Value Engineering Study

East Side Coastal Resiliency Project

April 2018

Preliminary
Value Engineering Study Report
for

Alternative No.: AD-10

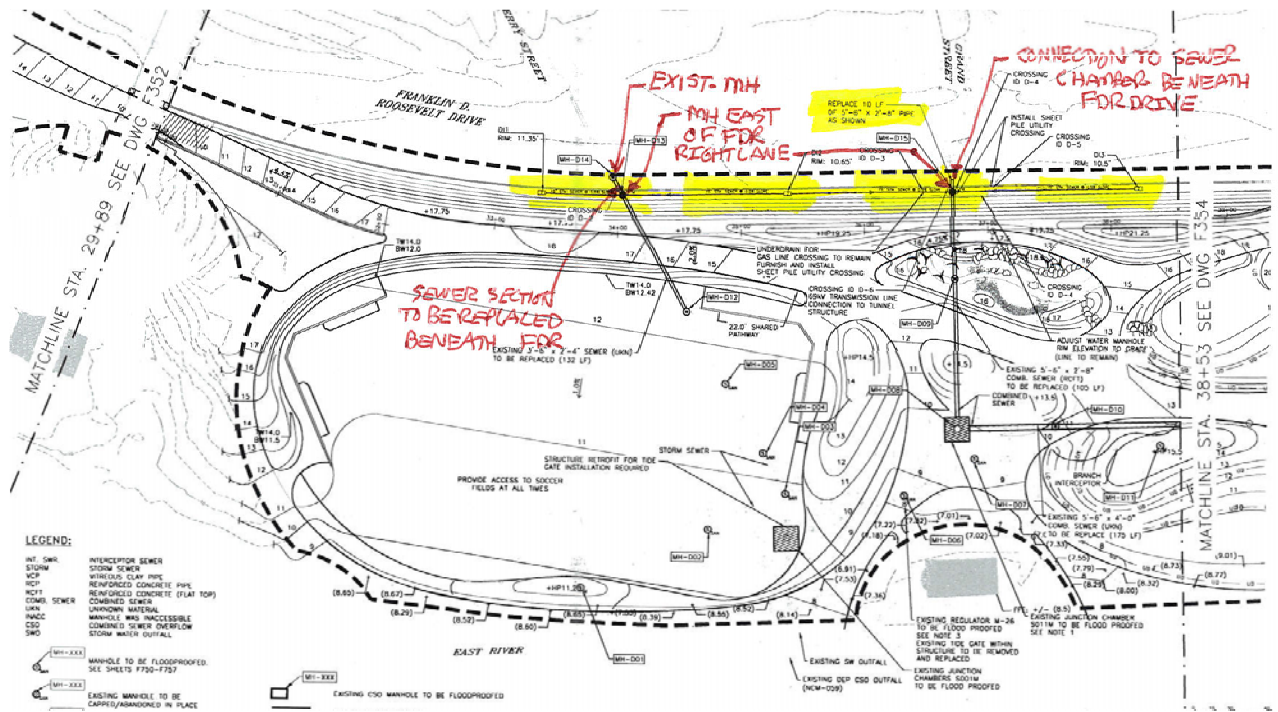
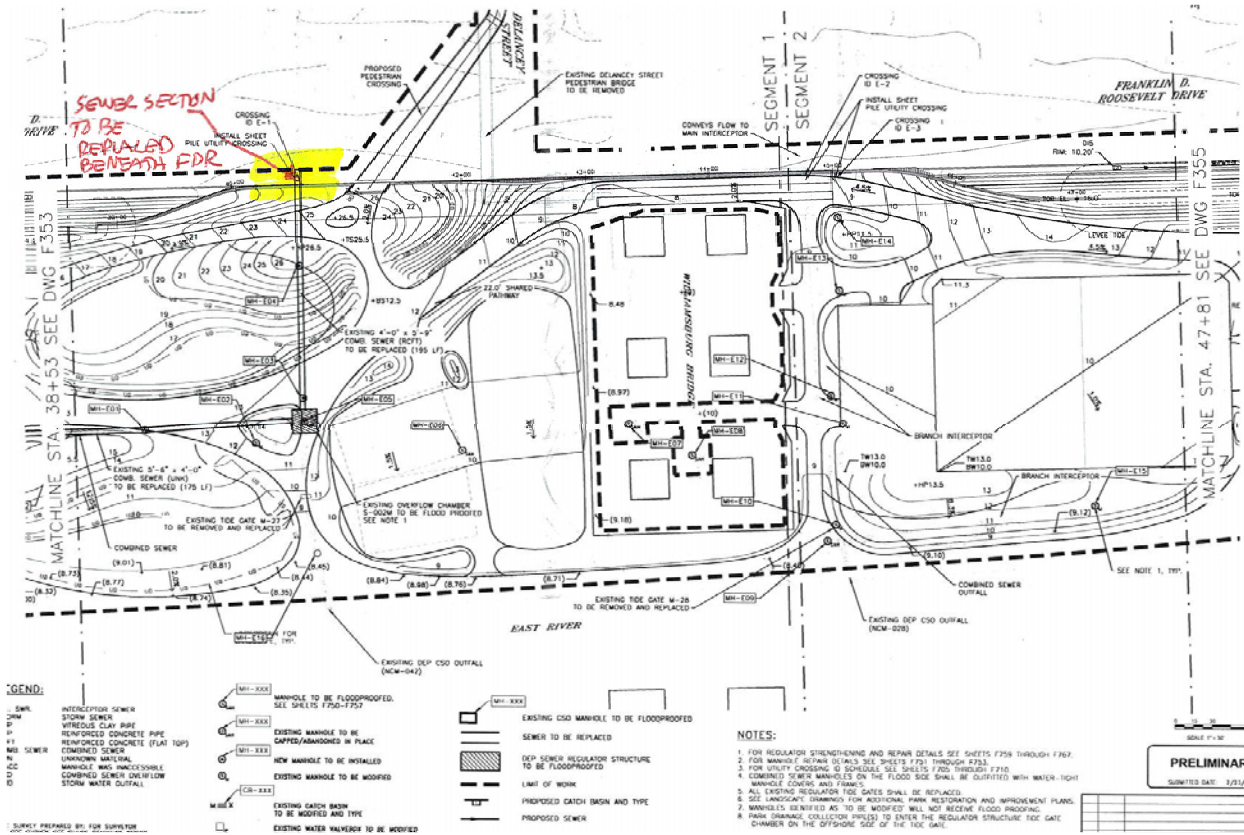
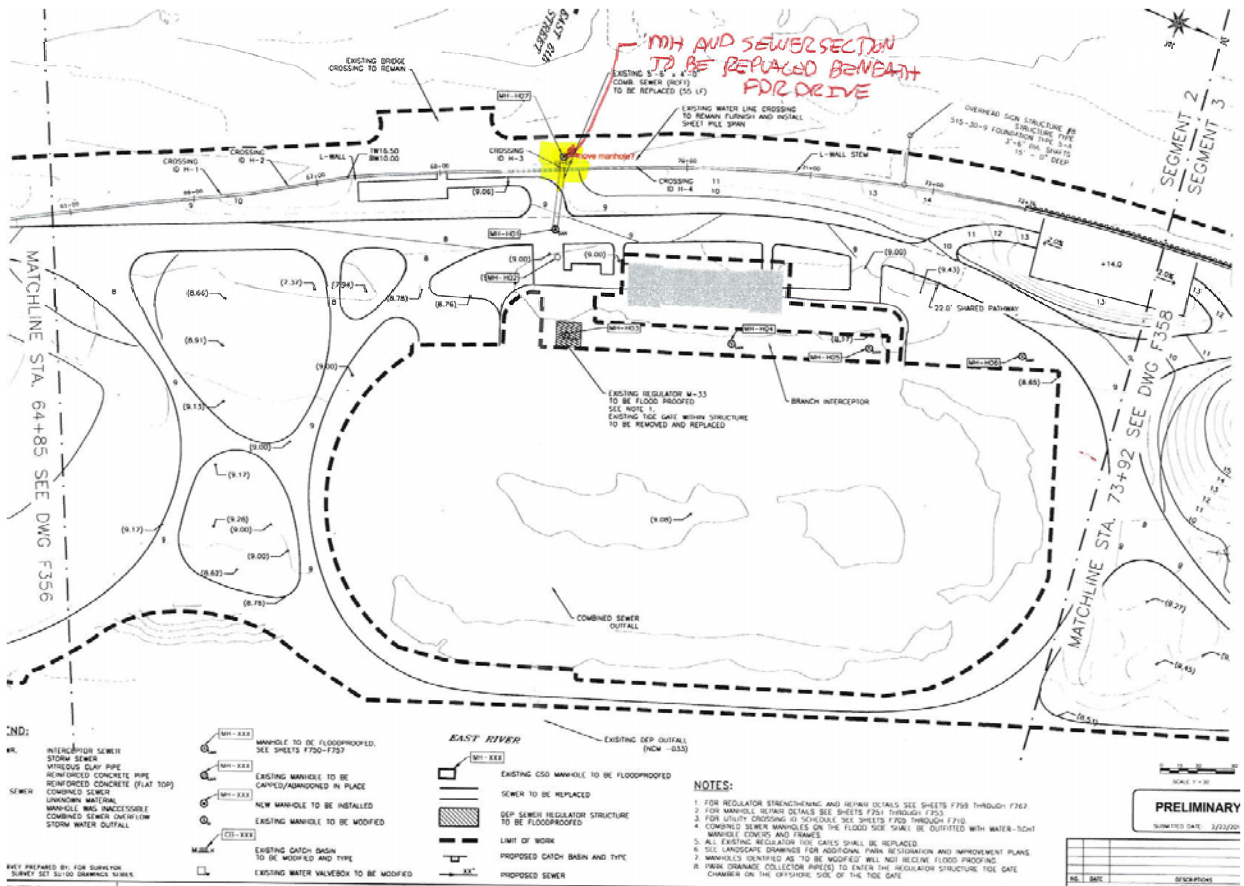
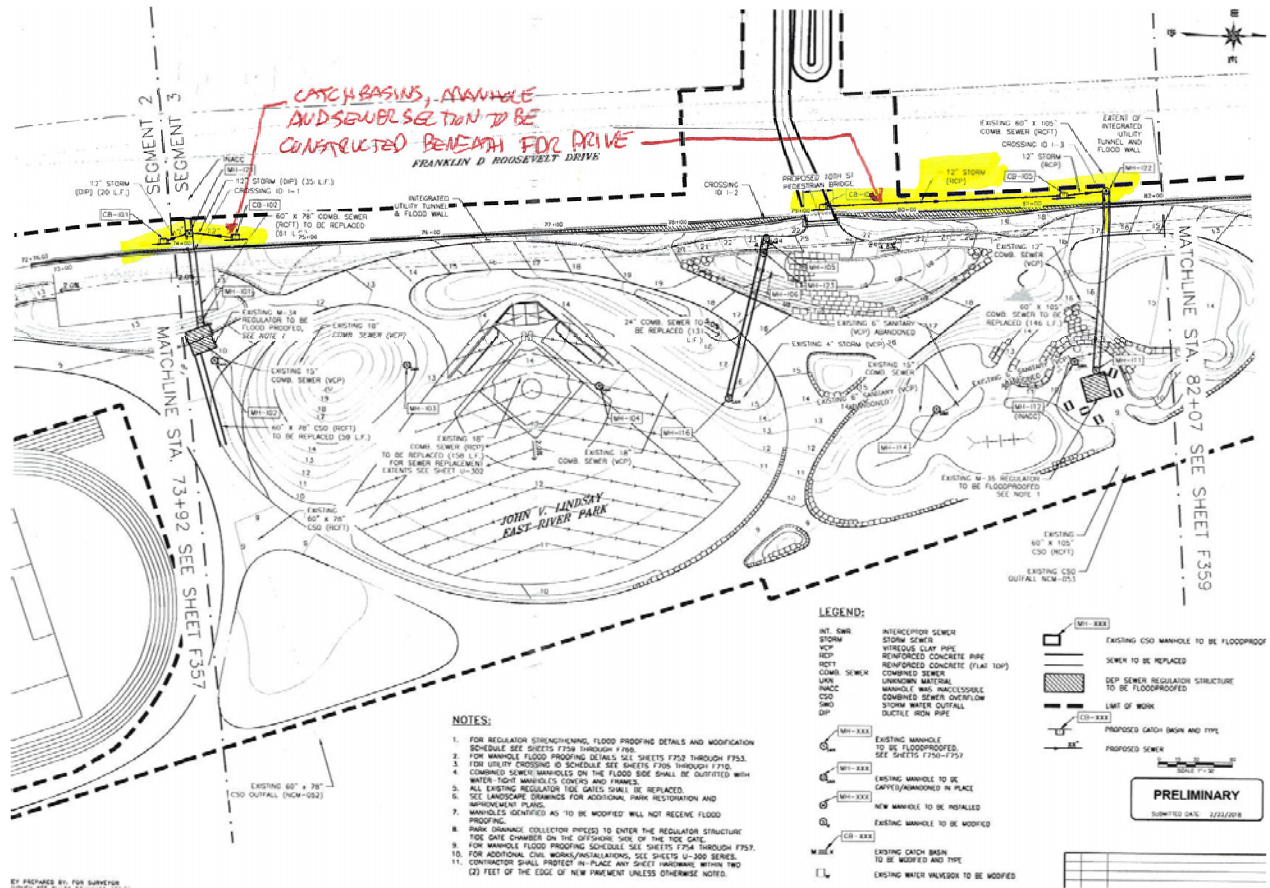
Construction, operation and maintenance requirements for the approximately 10 new CSO or storm drain manholes needed to access existing, reconstructed or replaced CSO discharge conduits to the East River would be greatly reduced by locating these manholes either on the new berm, in the park area (with flood-proofing of the structures) or west of the floodwall and FDR Drive.

Construction of these manholes would be prohibitively disruptive and, therefore, not preferred by the DOT. In addition, access to these manholes by DEP for O&M purposes would be similarly disruptive and unacceptable to both DOT and DEP.

Alternative No.: AD-23

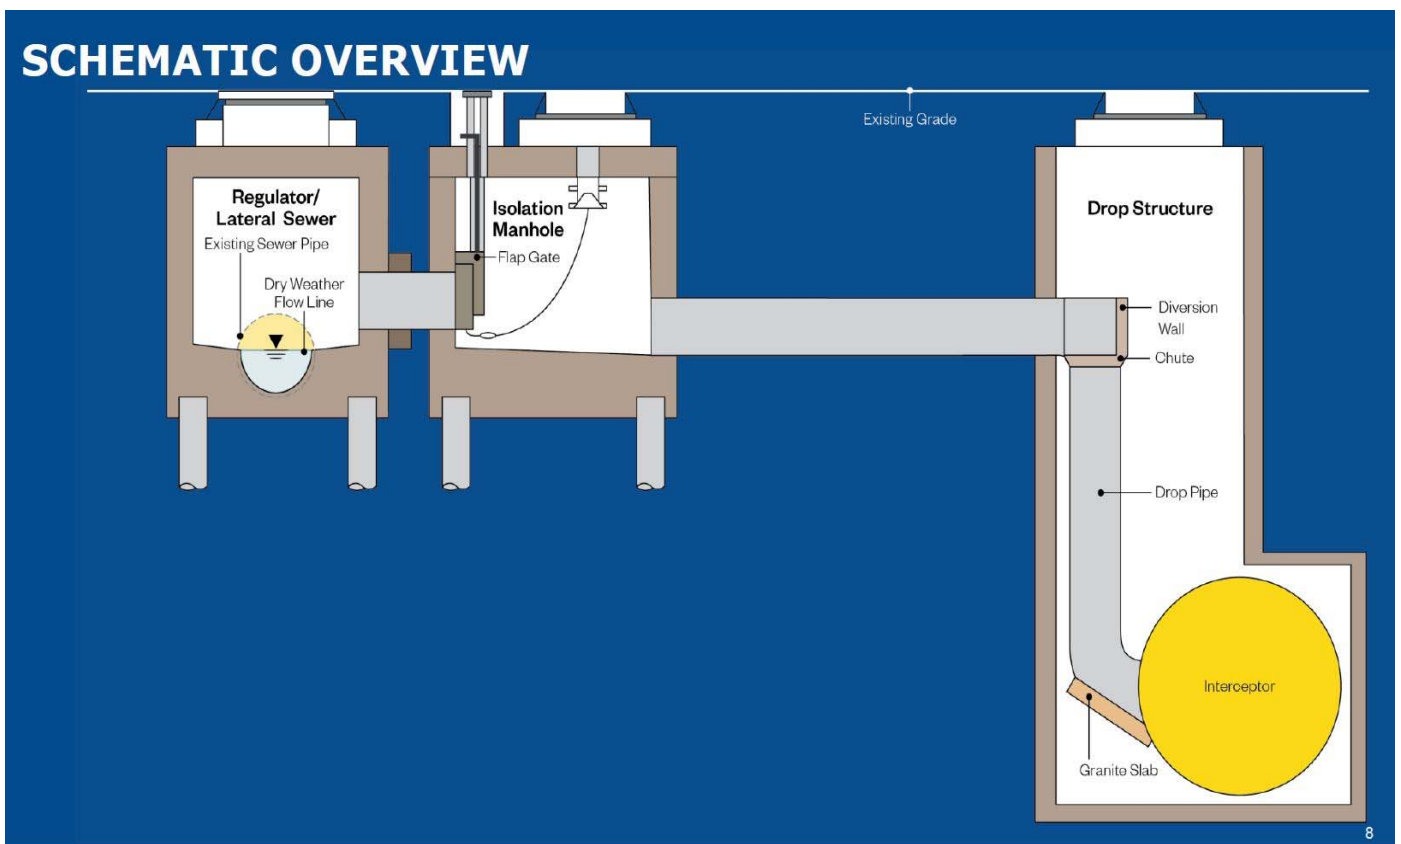
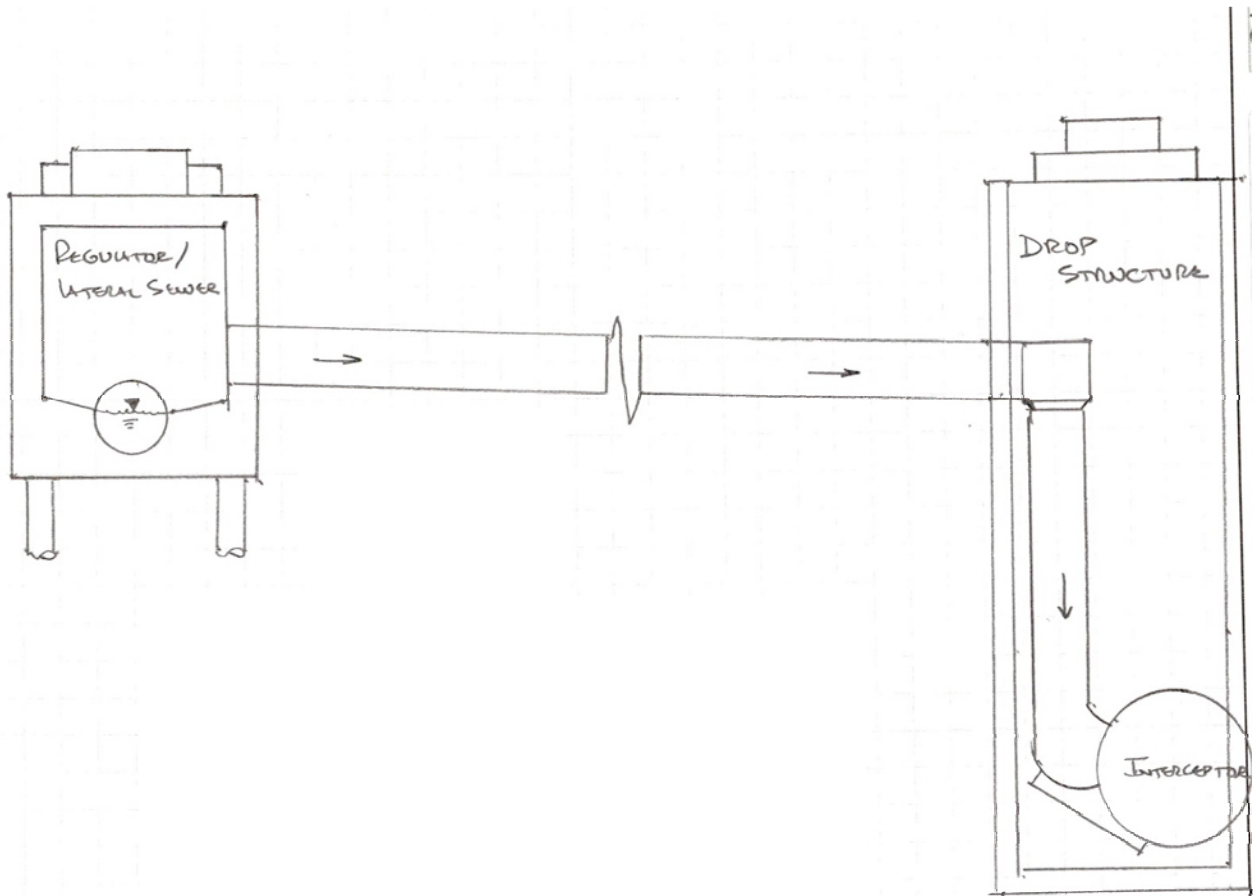
1. Clogging of the connecting pipes leading to the isolation chamber from the combined sewers. These pipes will accumulate sanitary solids, sediment and debris from storms smaller than those requiring opening of the flap gate in the isolation chamber. These solids will be very difficult to remove leading to their solidification, greatly reducing the capacity of the connecting pipes and the parallel conveyance system.

2. The isolation chamber gates are to be manually operated, requiring multiple staff both before and after major storm events to open and close the flap gates and to clean the pipes and mechanisms after each event to ensure future operability. Because of the uncertainty related to future meteorological conditions, decisions to mobilize staff to open these gates must be made early in a storm's occurrence to take advantage of the available capacity in the 108-inch interceptor and avoid surface flooding. The requirements for such a conservative decision process will lead to more frequent, unnecessary operation of the chambers. This translates to additional time for the O&M staff.

3. Without the benefit of detailed hydraulic analyses using the InfoWorks model, it appears likely that surcharging of the 108-inch interceptor to the Manhattan Pump Station will cause surcharging or backflow to the combined system with or without the proposed parallel conveyance conduits. Thus, the isolation chambers would be of little benefit hydraulically but is adding a substantial capital cost and poses very serious operation and maintenance problems that would render them inoperable and ineffective in any case.

Figure #1 Base Construction

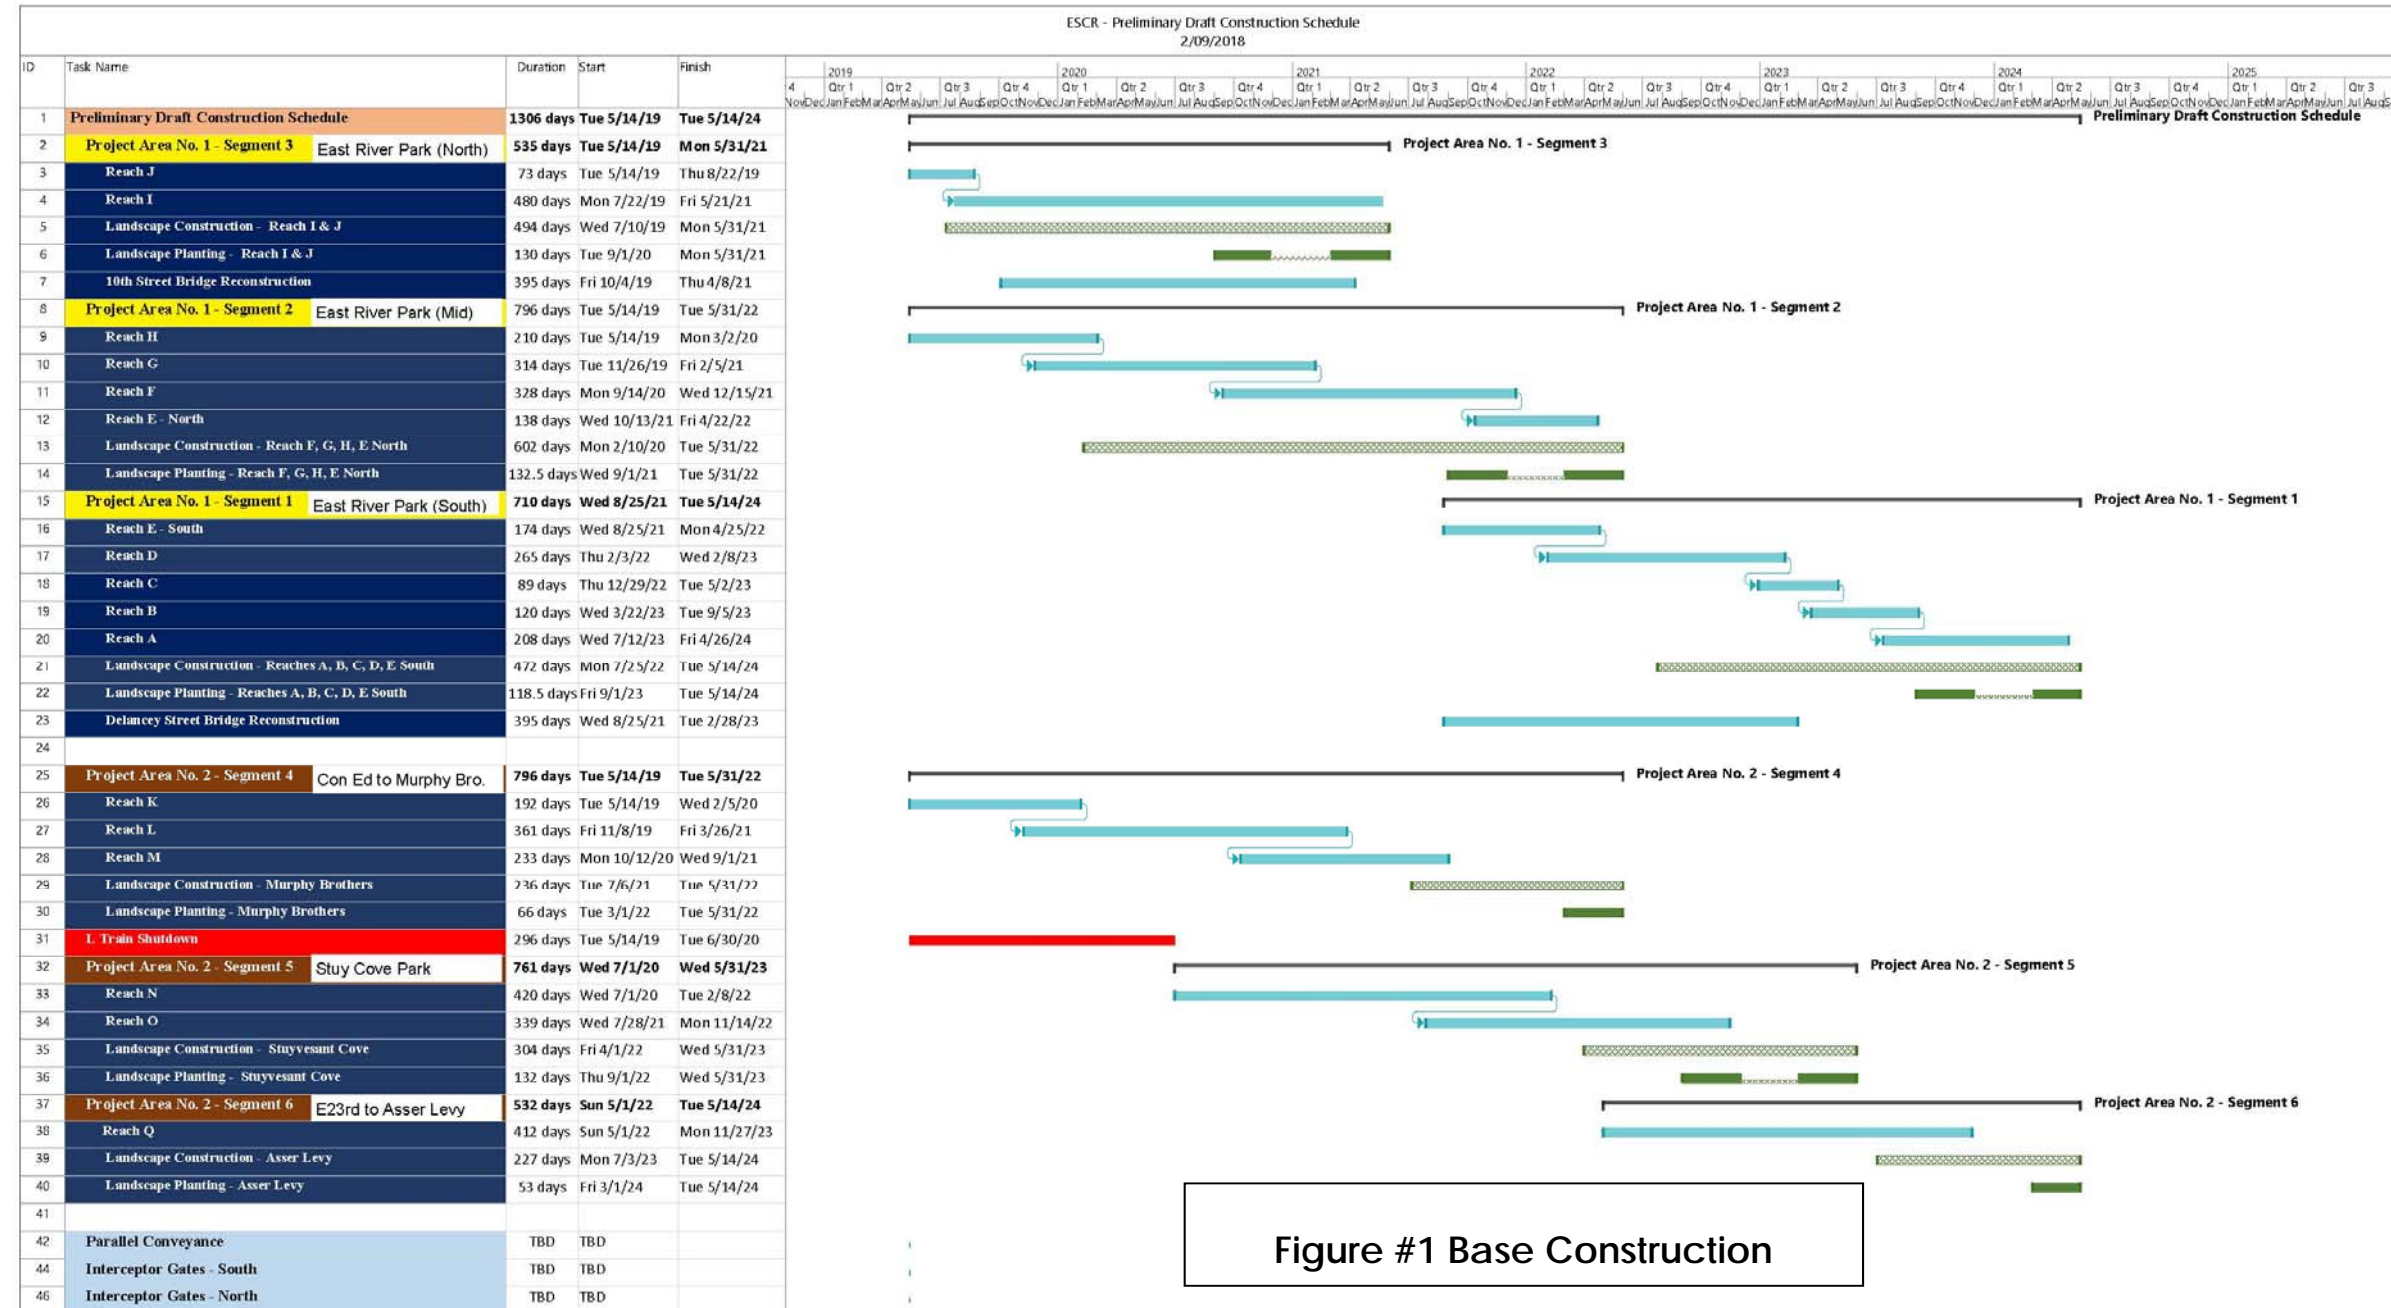
In order to facilitate early use of the HUD funding, a revised, non-linear sequencing approach is suggested that considers simultaneous early construction of ancillary, supporting work.

- c) Advance an **early earthworks construction and fill placement** contract for certain areas in the Park associated with utility work.
- d) Provide a **temporary construction berm at Houston Street** as an early contract. This has been estimated to cost \$11M. (See VE proposal C-51).
